[Docket No. FAA-2009-0514; Airspace Docket No. 07-AWA-1]

Amendment to Class B Airspace; Cleveland, OH

ACTION: Final rule.

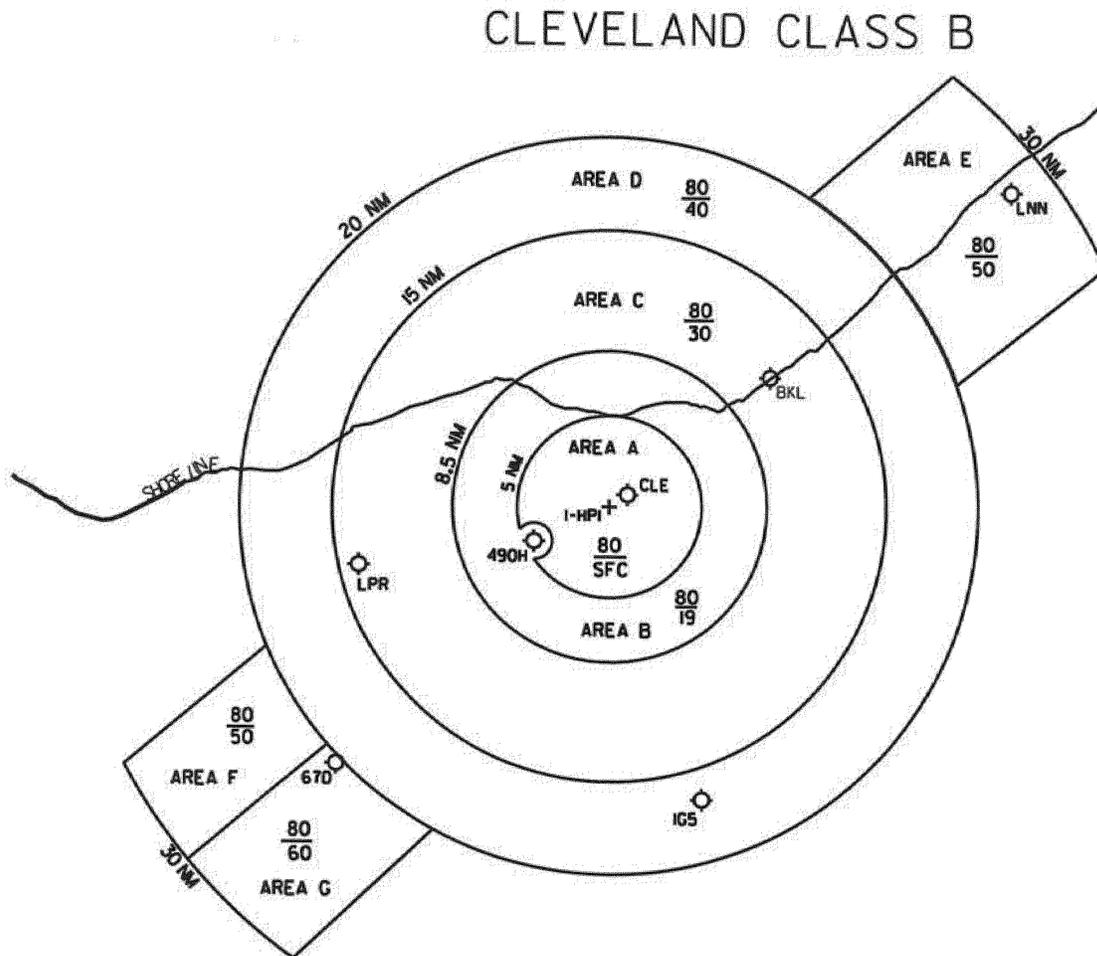
Seven commenters objected to proposed Areas F and G. They argued the FAA proposed these areas significantly larger than required or presented previously. Six of the commenters wanted the lateral dimensions of the areas reduced to only five nautical mile (NM) extensions in length by five NM in width. One commenter argued that federal airways are established with four NM lateral widths from a radial of a navigation aid and that the FAA should reduce the widths of the areas to four NM also. Three commenters wanted Areas F and

Eight commenters suggested the split floor altitudes proposed for Areas F and G (5,000 feet mean sea level (MSL) and 6,000 feet MSL, respectively) would cause confusion and probably some inadvertent Class B airspace incursions. The commenters stated the split level proposed design still presented a safety infringement to the glider operations at Reader-Botsford airport (67D) and offered multiple recommendations for changing the floor altitudes to remedy their concerns. Two commenters recommended raising the floor of Areas F and G to 6,000 feet MSL and 7,000 feet MSL, respectively; two commenters recommended making both floor altitudes 6,000 feet MSL; and three commenters recommended raising the Area G floor only to 7,000 feet MSL.

Eleven commenters stated that establishing the proposed Areas F and G extension would adversely affect flight safety beneath and in the near vicinity of the extension. The safety concerns cited included compression of general aviation aircraft under the extension where gliders operate, increased potential for mid-air collisions, wake turbulence effects on gliders from heavy aircraft arrivals on approach to CLE, and increased potential for off-field landings by glider pilots as a result of the extension overhead 67D.

Three commenters stated that the geographic coordinates [latitude/longitude] defining Areas F and G did not coincide with the text of the NPRM and needed to be redefined consistent with the dimensions briefed at the informal airspace meetings. Two of these commenters further noted that the southern boundary of Area G was not parallel with the Runway 6R centerline extended as proof the coordinates were in error.

The FAA does not agree. For clarity, the lateral dimensions of Areas F and G as proposed in the NPRM are 10 NM in length, extending from the CLE Runway 24L ILS/DME antenna (I-HPI) 20 NM arc to the I-HPI 30 NM arc. The areas are 6 NM in width, from the CLE Runway 6R localizer (I-CLE) signal extended to 6 NM north of the Runway 6L localizer (I-LIZ) signal extended for Area F and from the I-CLE signal extended to 6 NM south of the Runway 6R localizer (I-EYU) signal extended for Area G. These lateral dimensions were determined to be the absolute minimum essential to control IFR aircraft arriving from multiple arrival streams that are being sequenced in the traffic patterns for Precision Runway Monitor/Simultaneous Offset Instrument Approaches (PRM/SOIA) procedures into CLE. The length of these areas ensures the 15 to 18 percent of IFR aircraft arrivals that currently enter, exit, and re-enter the CLE Class B airspace (as noted in the NPRM) are fully contained within Class B airspace once they enter the traffic patterns to intercept the final approach course and the PRM/SOIA procedures. During periods of moderate and heavy traffic, aircraft may be turned onto the PRM/SOIA finals as far as 25 NM to 30 NM from CLE, as is the case today. The width of these areas ensures IFR arrival aircraft conducting PRM/SOIA are contained within Class B airspace while flying in the traffic patterns and are safely separated, in accordance with aircraft separation standards and guidance, between non-participating VFR aircraft that may be flying along the boundaries of Areas F and G and IFR aircraft flying the instrument approach procedures to Runways 6L/6R. To reduce the lateral dimensions (length or width) of the Areas F or G Class B airspace extensions would be impractical.

The FAA does not agree and has determined it is not possible to raise the floor altitude of either area without impacting the operational efficiency of the PRM/SOIA into CLE. Again, for clarity, the vertical dimensions of Areas F and G as proposed in the NPRM are from 5,000 feet MSL to and including 8,000 feet MSL for Area F and from 6,000 feet MSL to and including 8,000 feet MSL for Area G. Initially, the Class B airspace extension to the southwest in the same airspace proposed as Areas F and G was designed as a single area with a floor altitude of 5,000 feet MSL. After receiving public input from the ad hoc committee and public comments following the informal airspace meetings recommending the configuration proposed, the subdivision and altitudes of the two areas were proposed using the minimum amount of airspace necessary to contain PRM/SOIA procedures to Runways 6L/6R at CLE.

The FAA does not agree. The coordinates published in the NPRM regulatory text for defining Areas F and G were validated with the FAA's Aeronautical Navigation Procedures Group and found to be correct and consistent with the text published in the NPRM. The FAA acknowledges that

Areas F and G proposed in the NPRM differ from what was presented during the informal airspace meetings. However, the proposed Areas F and G airspace published in the NPRM is the minimum necessary to reasonably contain IFR arrival aircraft flying PRM/SOIA procedures to runways 6L and 6R, and the geographic coordinates published accurately reflect these areas. With respect to the comments about the southern boundary of Area G, the commenters are correct that the boundary is not parallel to the runway 6R centerline extended. The northern and southern boundaries of the Area G are defined from different navigation aids. The northern boundary is defined by the Runway 6R localizer (I-CLE) signal extended, and the southern boundary is defined 6 miles south and parallel to the Runway 6R localizer (I-EYU) signal extended. This accounts for the fact that the southern boundary of Area G is offset by 3 degrees and is not parallel to the northern boundary.
